**PLANNING DEPARTMENT
STAFF ANALYSIS
CONDITIONAL USE**

DATE: June 6, 2016
CASE NUMBER: 2016-0053
APPLICANT: Girdwood Brewing Company
REQUEST: Conditional use to allow general manufacturing in the gC-10 (Upper Alyeska Highway commercial) district
LOCATION: Alpine View Estates Subdivision, Phase 3, Tract B-2C per Plat 2014-38
SITE ADDRESS: 2700 Alyeska Highway
COMMUNITY COUNCIL: Girdwood Board of Supervisors
TAX NUMBER: 075-163-44
SITE: ±46,385 SF
CURRENT LAND USE: Vacant
UTILITIES: Public water and sewer is available
TOPO: Minimal slope downhill to the southwest
VEGETATION: Birch, spruce, and undergrowth

**Plot Plan
 Tract B-2C
 Alpine View Estates, Phase 3**

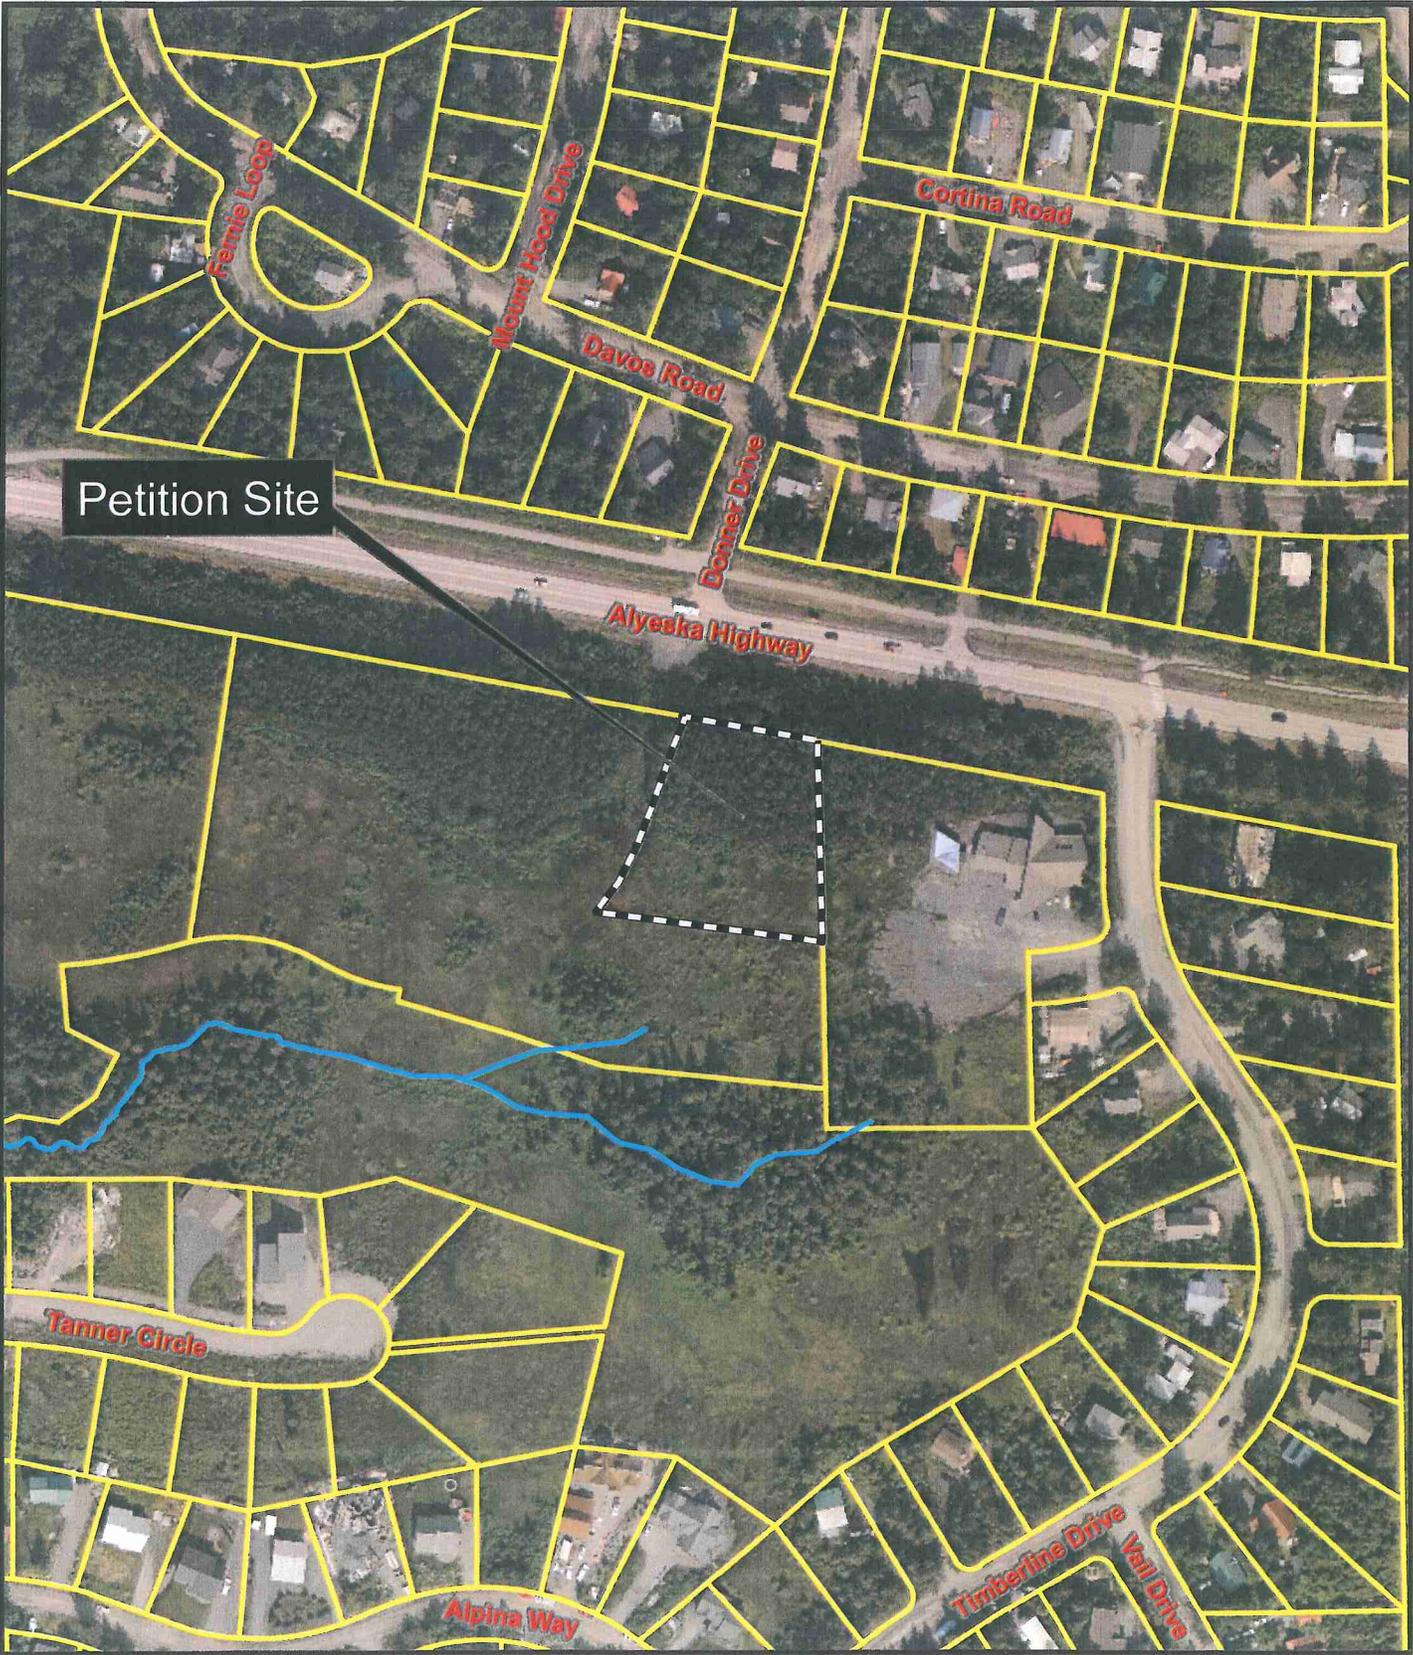
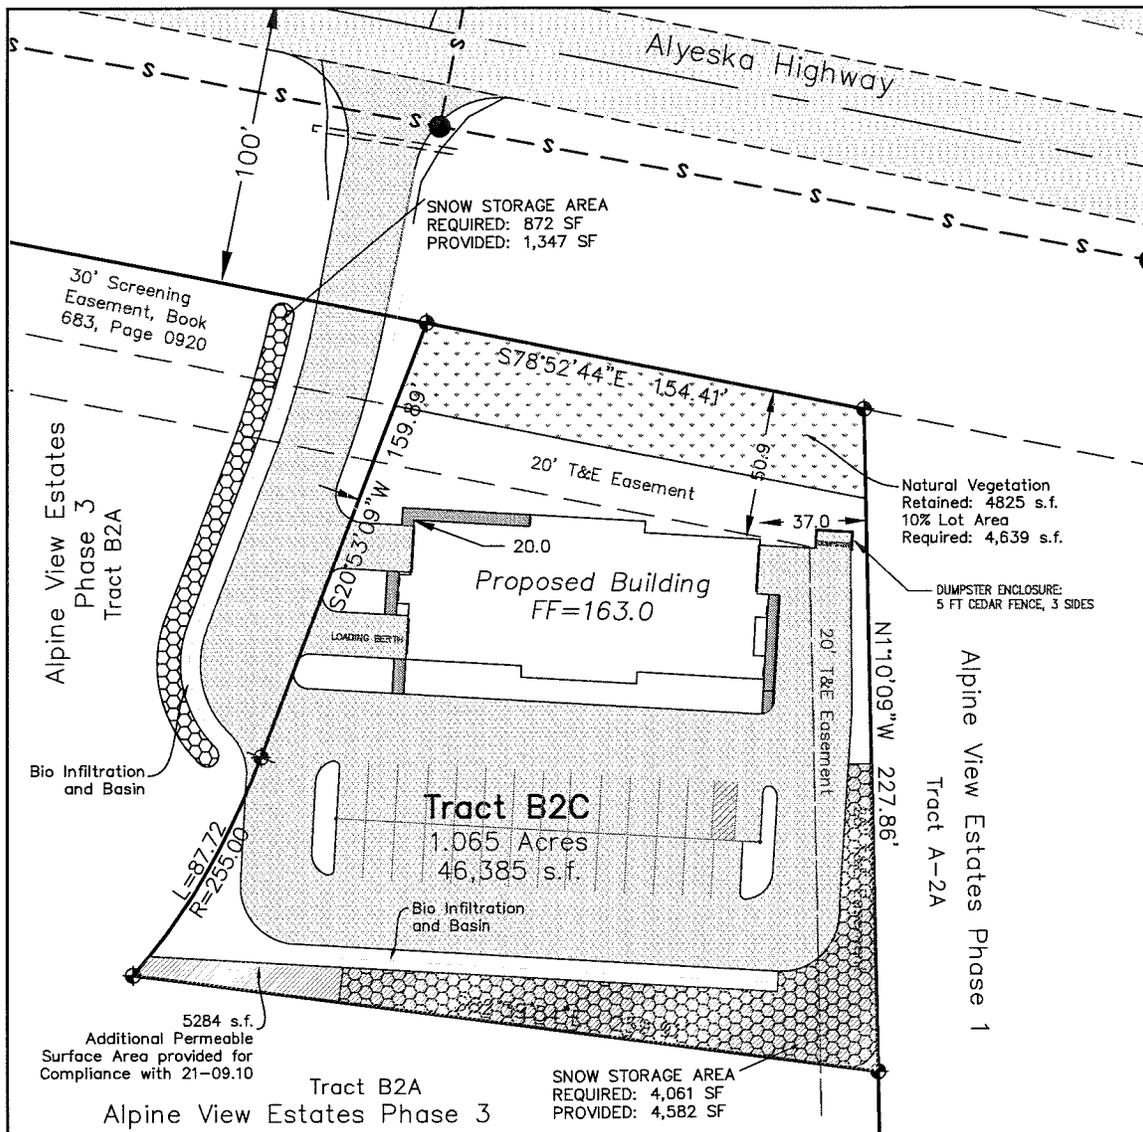
Yard setbacks: The site plan appears to meet the required setbacks (25-foot front, 20-foot side, and 20-foot rear). The site plan needs to dimension the corner of the building closest to the west property line to verify that the 20-foot side setback is met.

The site plan shows a shared driveway located on the neighboring property to the west (Tract B2A). No pedestrian routes are provided from the building to the Alyeska Highway. Pedestrians will be forced to walk through unpaved areas or in the driveway. Glacier Valley Transit serves the property. The Traffic Department recommends that the site plan show an ADA pedestrian pathway from the Alyeska Highway to the sidewalk attached to the building. Planning agrees with the Traffic Department that a paved pathway is warranted, but it should not be required to meet ADA grades due to existing topography affecting the site.

The standard is not met. The site plan shows a walkway around sections of the north, east, and west sides of the building. There is no walkway on the south elevation of the building adjoining the parking lot. Also, there is no walkway to the entrance of one of the dwelling units. The walkway must be a minimum of five feet wide and the roof overhang is required to cover the walkway for protection from falling snow. No walkways are provided from the building to the parking area, but given that the parking area is small, a walkway may not be necessary.

The standard is met. The site plan requires a minimum of 14 parking spaces and 28 spaces are provided. The site plan should label the parking lot as being paved, in accordance with AMC 21.09.070L.8. No loading facility is required, however, one is provided on the west side of the building.

The standard is not met. The site plan shows a 30-foot wide driveway. The maximum allowable width is 24 feet unless approved by the Municipal Traffic Engineer. Also, the site plan should label the driveway as paved.

3. Obtain jurisdictional determination approval from the U.S. Corps of Engineers.
4. Dimension the distance between the corner of the building and the west lot line to verify that the 20-foot side setback is met.

5. Provide a paved pedestrian pathway from the Alyeska Highway to the sidewalk attached to the building.
6. Extend the sidewalk on the north side of the building to meet the sidewalk shown on the east side of the building so that there is a sidewalk all the way around the building.

9. Add a label to the site plan to show paved parking as required by AMC 21.09.070L.8. *Parking Surface Materials.*
10. Revise the site plan to show a 24 foot wide driveway, in accordance with AMC 21.09.070N.3. *Driveway Standards for Commercial Districts and Nonresidential Uses in Residential Districts*, unless an alternative width is approved by the Municipal Traffic Engineer.

11. Revise the site plan to show a paved driveway, in accordance with AMC 21.09.070N.3. *Driveway Standards for Commercial Districts and Nonresidential Uses in Residential Districts.*

GRADING PLAN
 ALPINE MEW ESTATES, PHASE 3
 TRACT B-2C

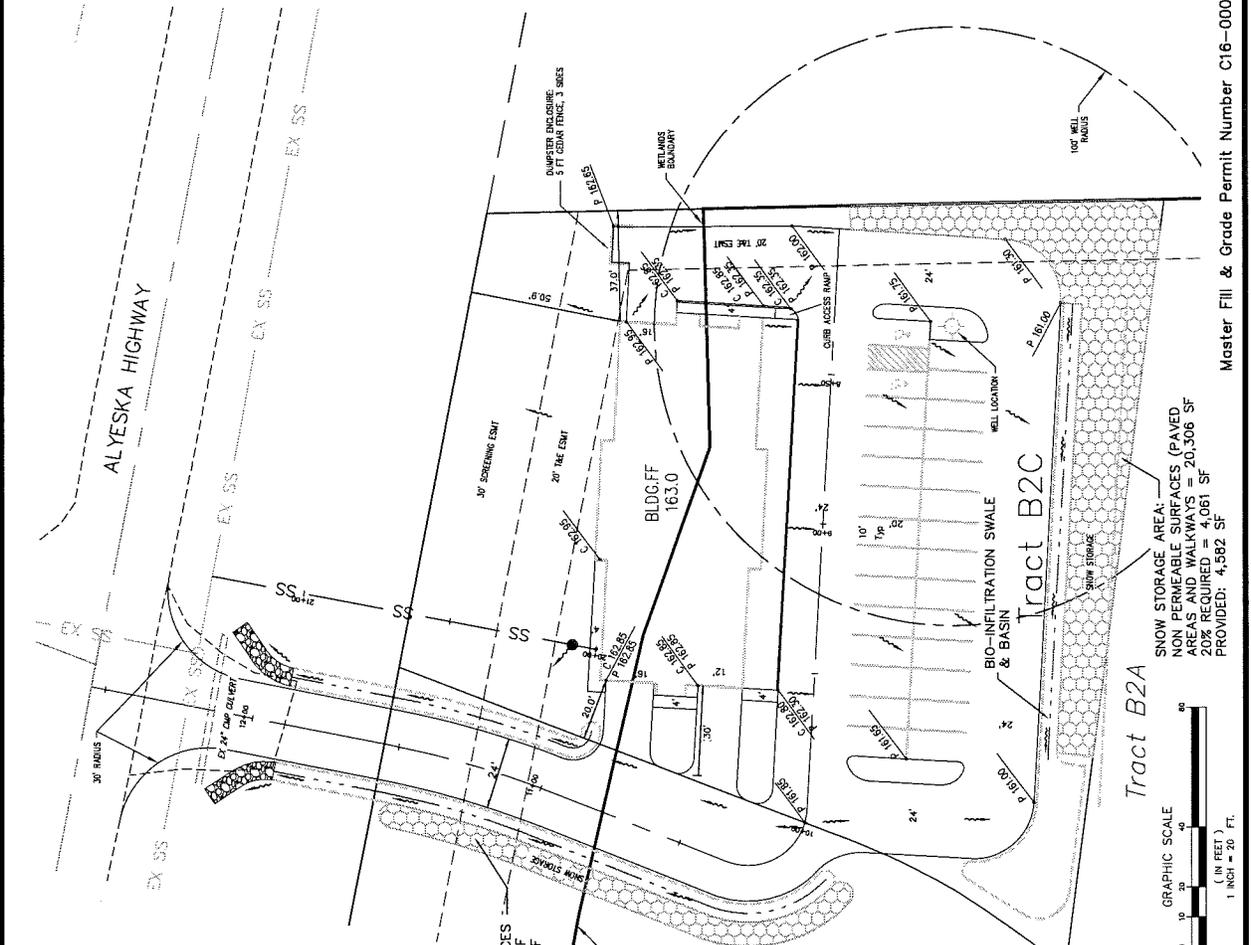
A review of the site plan shows an area to be used for stormwater runoff infiltration and snow storage. There has been no analysis to determine if this area as shown is the right size to contain or infiltrate the runoff. Also the MOA does not approve joint use of areas for snow storage and stormwater runoff. When the infiltration area is filled with snow the ability of the area to infiltrate stormwater during spring breakup is greatly reduced. If it is found the size of the infiltration area is not large enough, the site plan may need to be altered at a later date.

SHEET TITLE: ELEVATIONS	
FORM NO.	4304A
DATE	5/23/98
DRAWN	PKW
CHECKED	ESD
NO.	REVISION
DATE

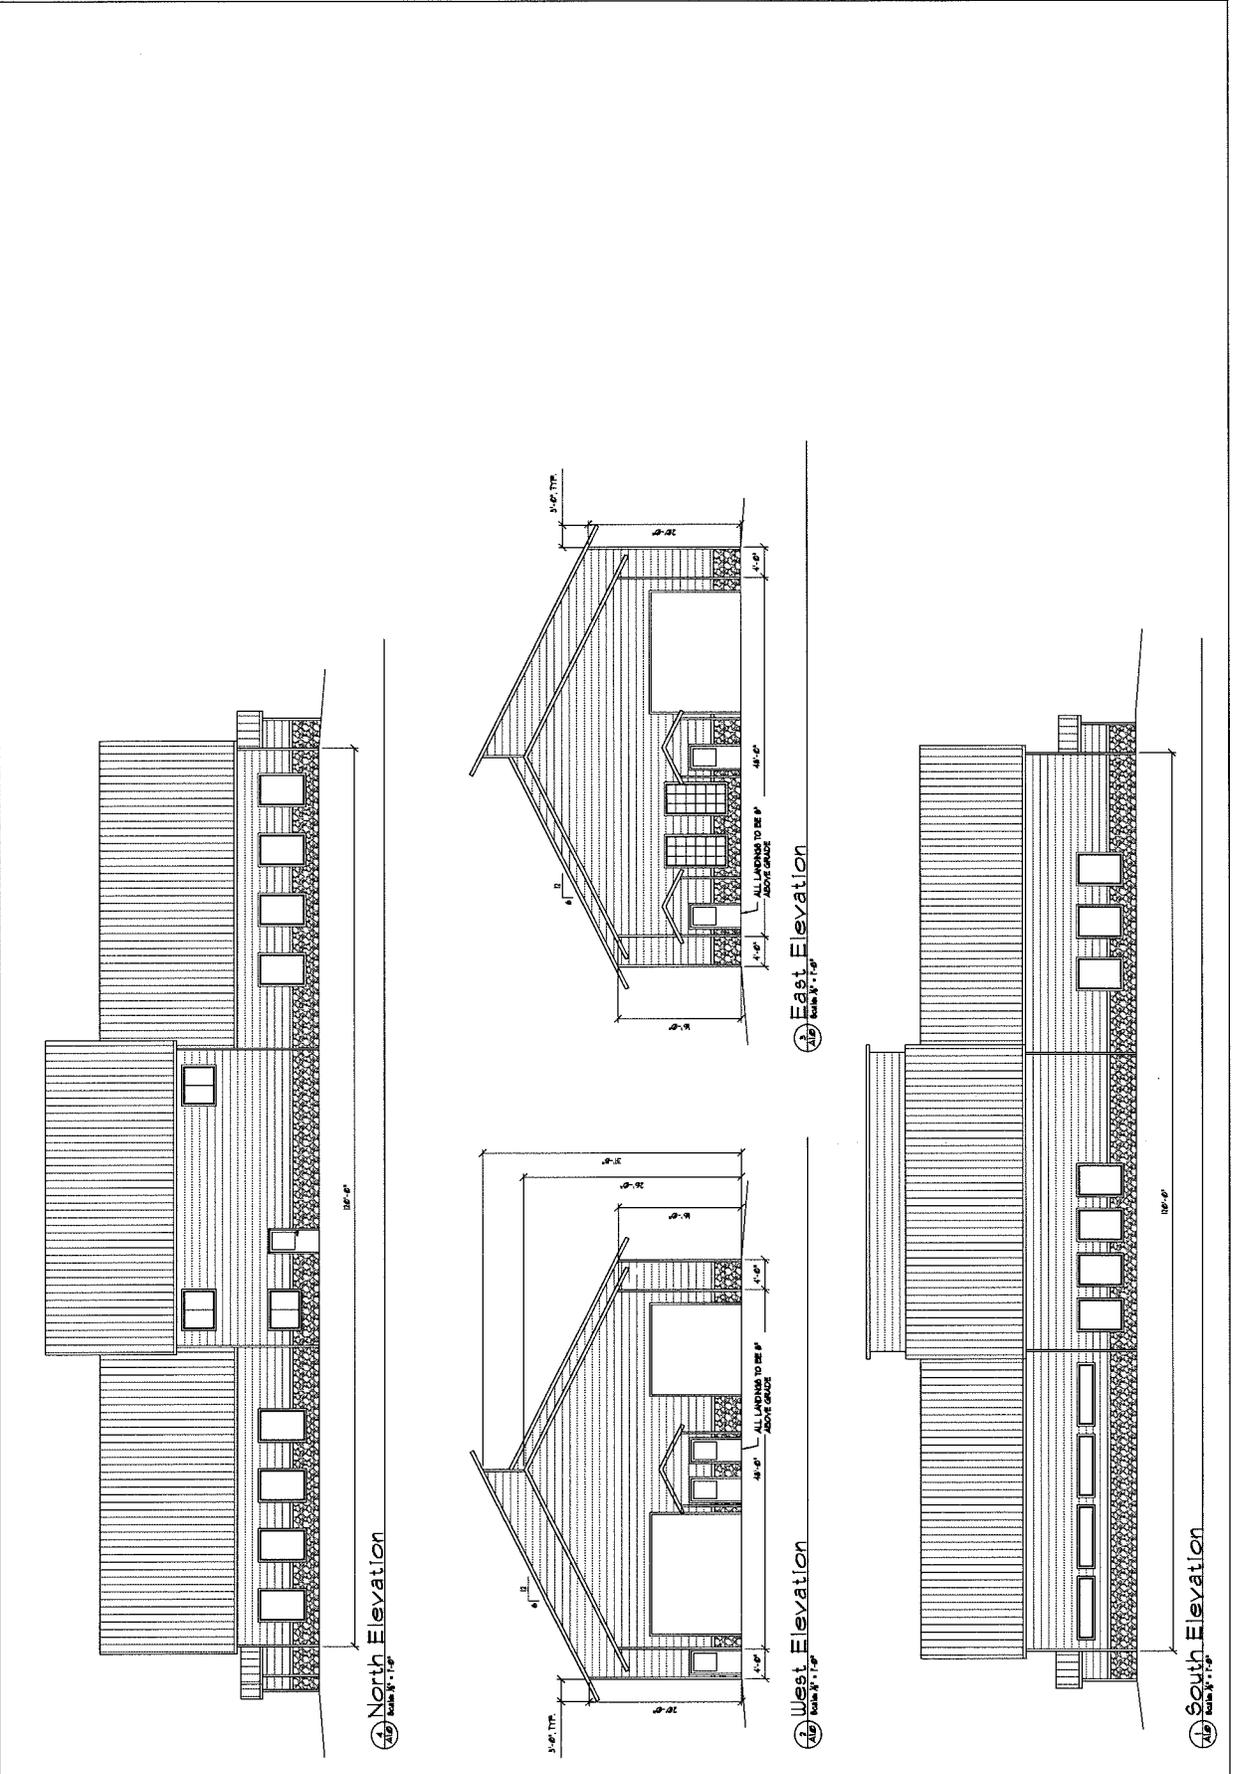
The standard is met. The north and south building elevations are 120 feet long and have four foot deep wall changes every 40 feet as required. The east and west building elevations are 48 feet long and provide the required four-foot deep wall modulations.

Standards "A" and "C" are not met. The façade of the brewery tasting room and yoga studios do not provide horizontal or vertical mullions and sashes to subdivide the windows into small panes as required by (A). Also, no windows angled windows, such as bay windows, or recessed doorways are provided as required by (C).

The standard is not met. The roof pitch is 6:12 which is permitted with at least 2.5 feet of eave overhang, which the building does not have. The roof pitch should be revised to 8:12 or provide the required overhang.

The standard is not met. No porch rails are proposed. The building elevations should be revised to show porch rails.

12. Revise the building elevations to show compliance with AMC 21.09.080F.2.f.i(A) and (C) *Design Elements.*
13. Revised the roof pitch to 8:12 or provide the required 2.5-foot eave overhang as required by AMC 21.09.080F.3.a. *Pitch.*

14. Revise the building elevations to show porch rails as required by AMC 21.09.080F.4.b. *Rails.*
15. Revise the building elevations to show weather protected entrances as required by AMC 21.09.080F.4.c. *Entry Size.*
